STATE OF HAWAII
DEPARTMENT OF TRANSPORTATION
HIGHWAYS DIVISION

INTERSTATE ROUTE H-1
Kunia Interchange Improvements
F. A. I. Project No. 1M-HI-1(219)

SHEET No. *L19-B* OF 52 SHEETS

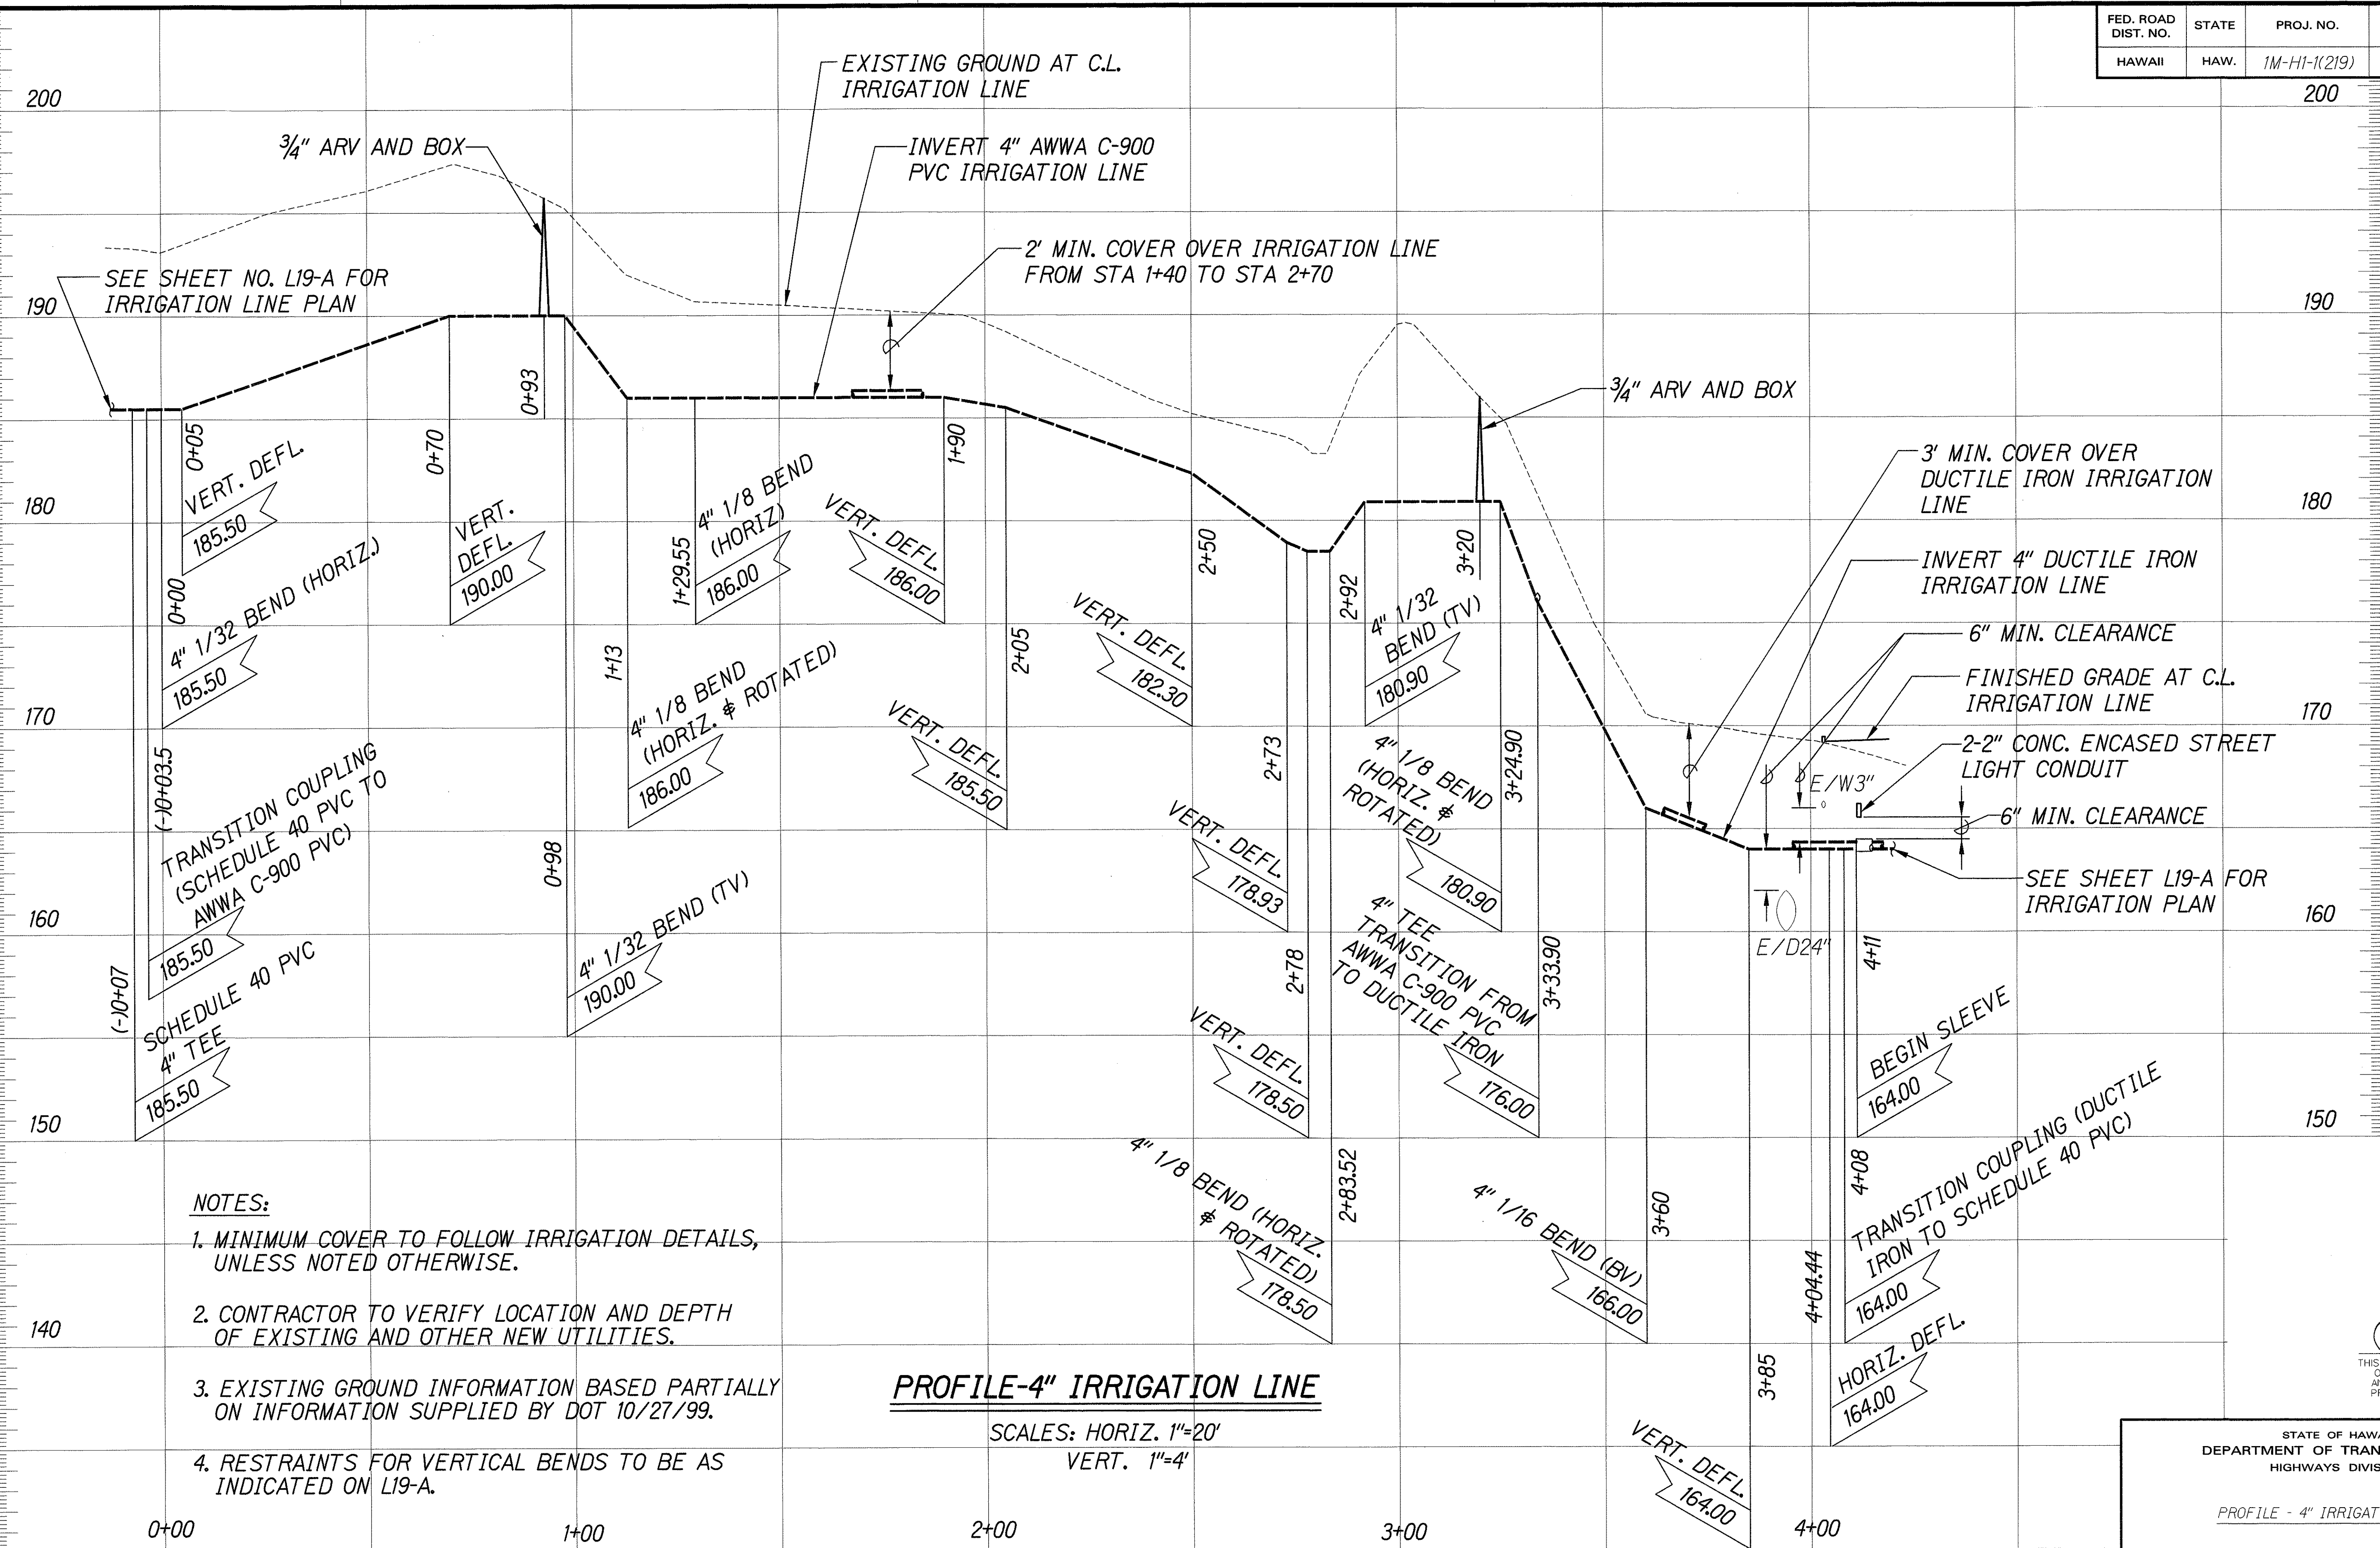
11/1/99	New Sheet with Profile of Revised Alignment of Irrigation Line.
DATE	REVISION

SHEET No. L20 OF 52 SHEETS

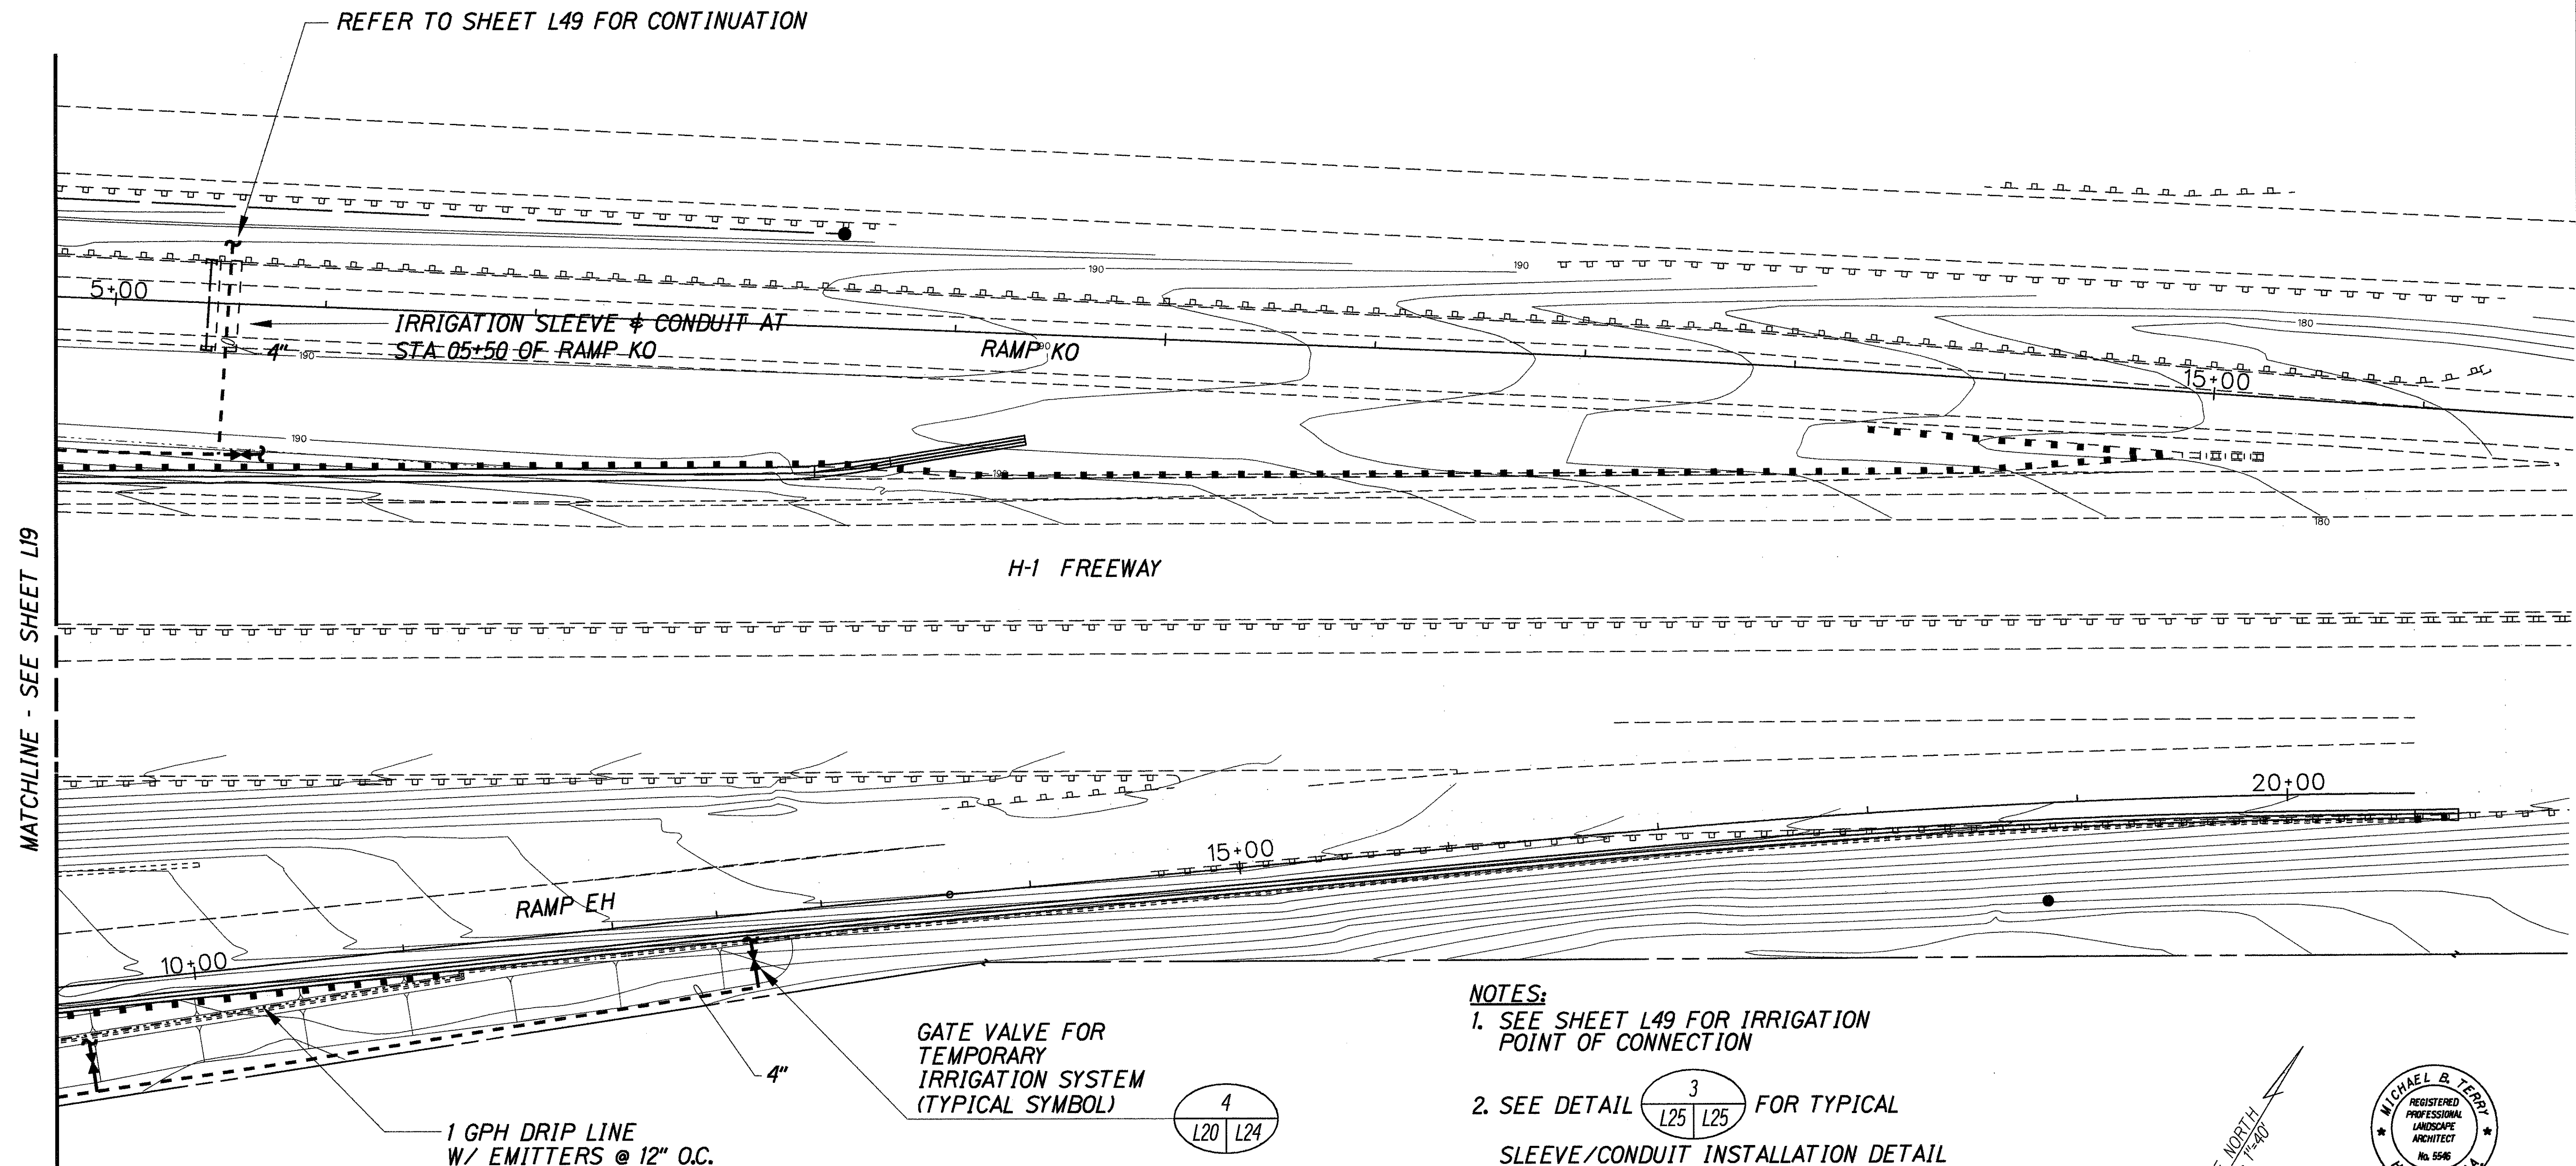
8/17/98	Revised Sheet to Add Dripline in Front of Noise Wall Along Ramp EH.
DATE	REVISION

SHEET No. L21 OF 52 SHEETS

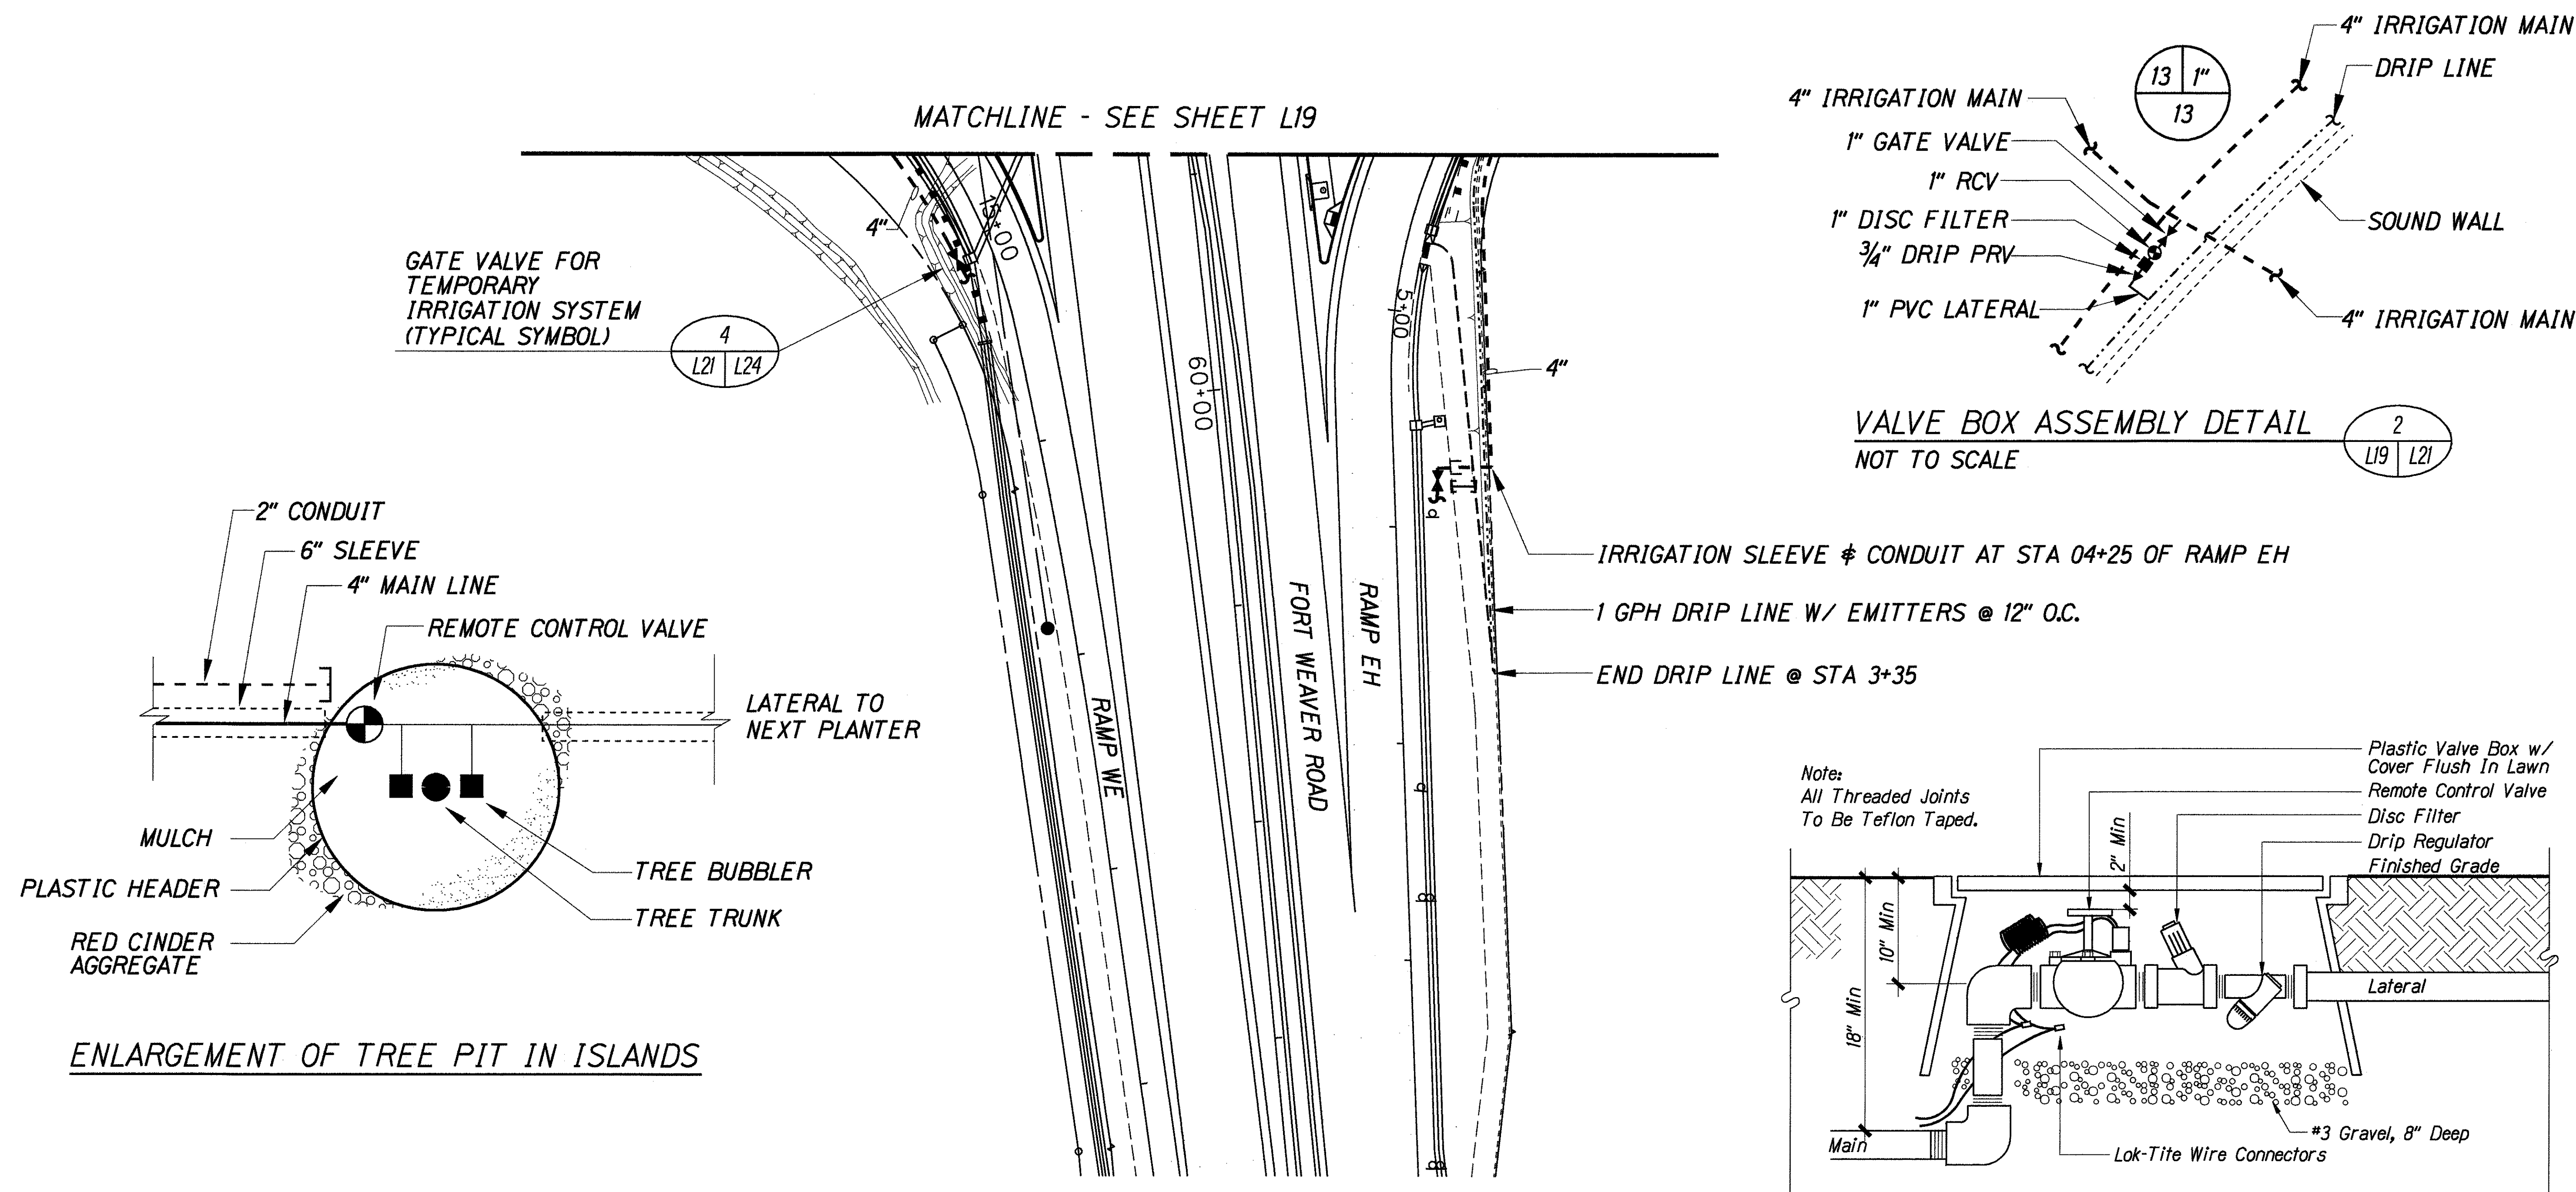
8/17/98	Revised Sheet to Add Dripline in Front of Noise Wall Along Ramp EH.
DATE	REVISION
